## Product/Process Change Notice (PCN)

PCN #: PCN\_ConMPC3\_20160722

Product Affected: 6620xx236022 6621xx236022  
 6620xx230822 6621xx230822 6620xx231722  
 6621xx231722 6620xx2308222

#### OLD DESIGN

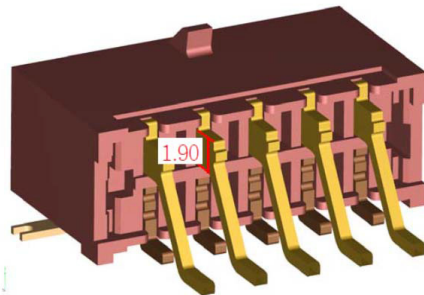
The external design, at plastic body base, of upper row pins will be changed to a bigger size to increase the efficiency of the assembling process.

Tolerance:  $\pm 0.1$  mm

#### NEW DESIGN

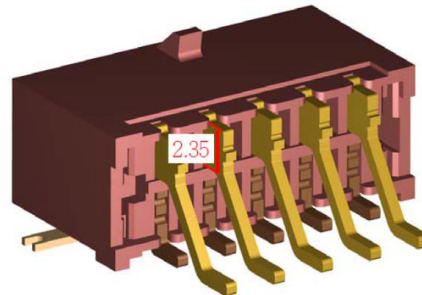
Tolerance:  $\pm 0.1$  mm
